ADMINISTRATIVE AMENDMENT NOTICE

Petitioner #: 2011-041

Brightmore of Charlotte
Senior Living Community
10021 Providence Road West
Charlotte, NC

SUBJECT: Administrative Approval for Petition No. 2011-041 Liberty Properties of
Mecklenburg County

RZ-2

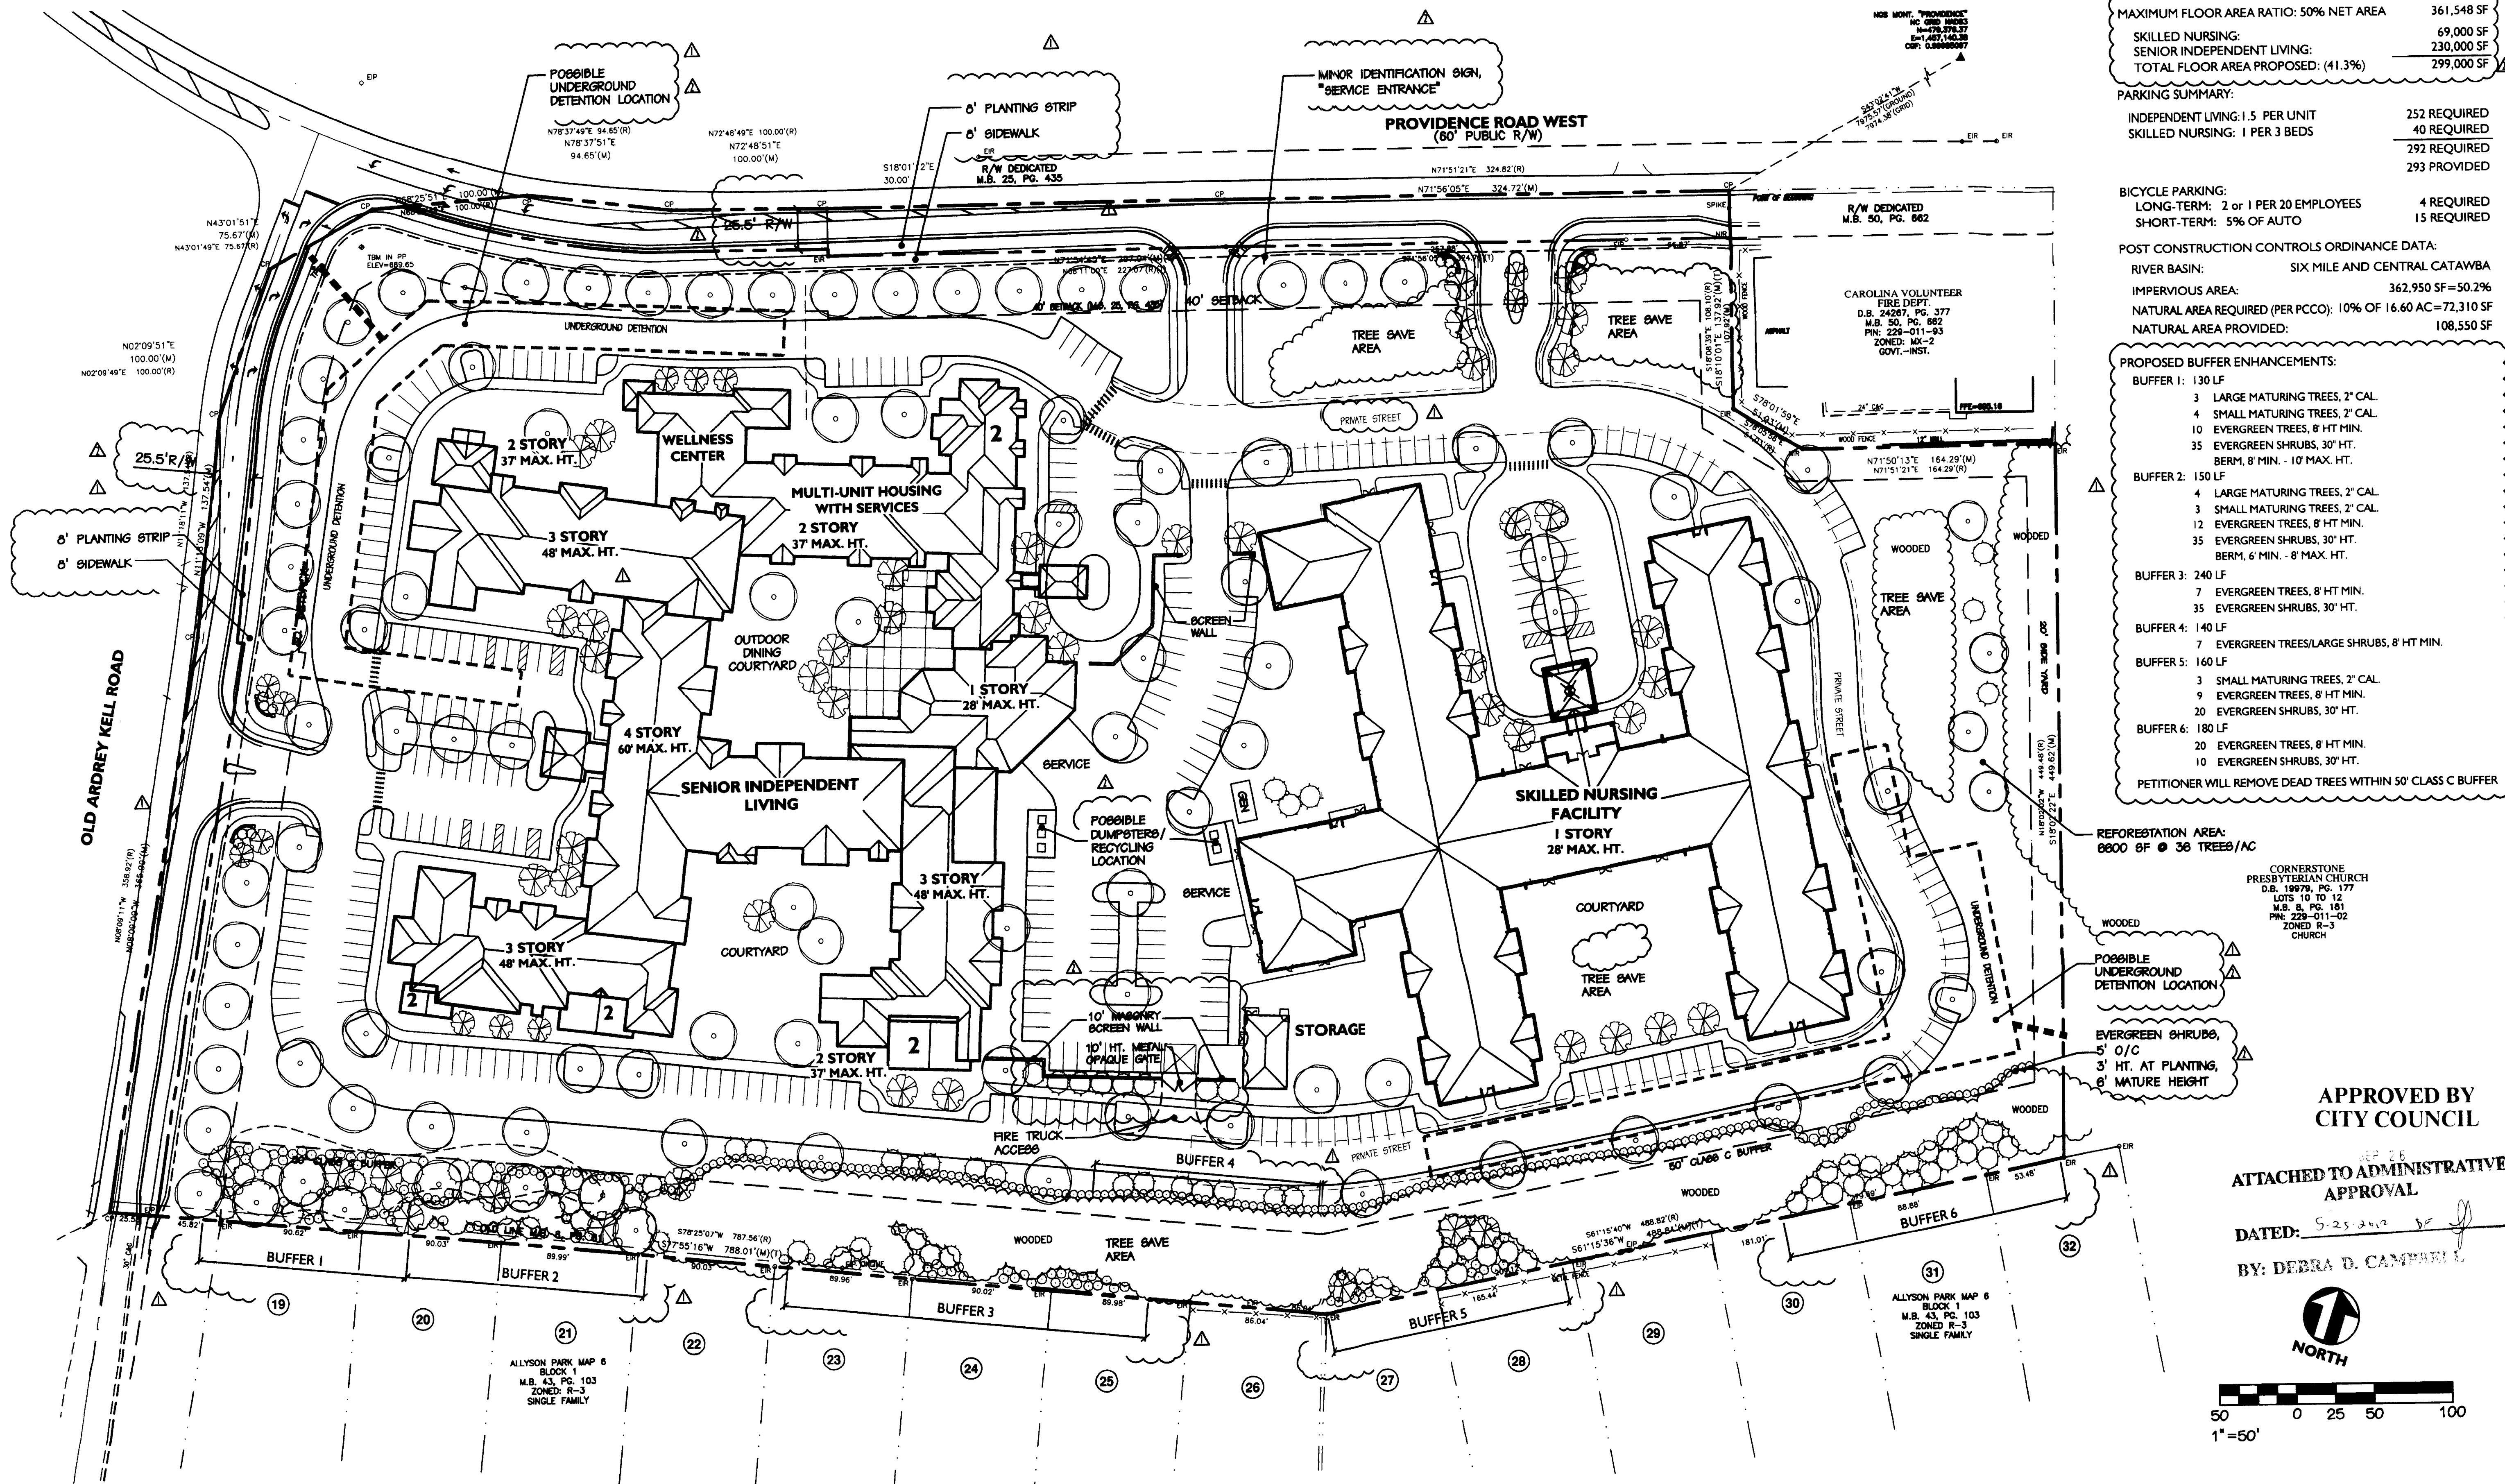
The amendment makes a minor change to the approved Rezoning Petition to *modify the approved site layout*, in accordance with Section 6.207 of the City of Charlotte Zoning Ordinance. Adjacent property owners may appeal the approval of the administrative amendment in writing to the Zoning Committee of the Planning Commission twenty-one days from the date of this notice.

Attached are the revised site plans for the above referenced rezoning petition. The plan shows the required width of dedicated right-of-way to be 25.5 feet along the public streets. Since this change does not alter the intent of the development and meets the requirements of the Charlotte Zoning Ordinance Section 6.207 Alterations to Approval, minor changes, I am administratively approving this plan. Please use these plans when evaluating requests for building permits and certificates of occupancy.
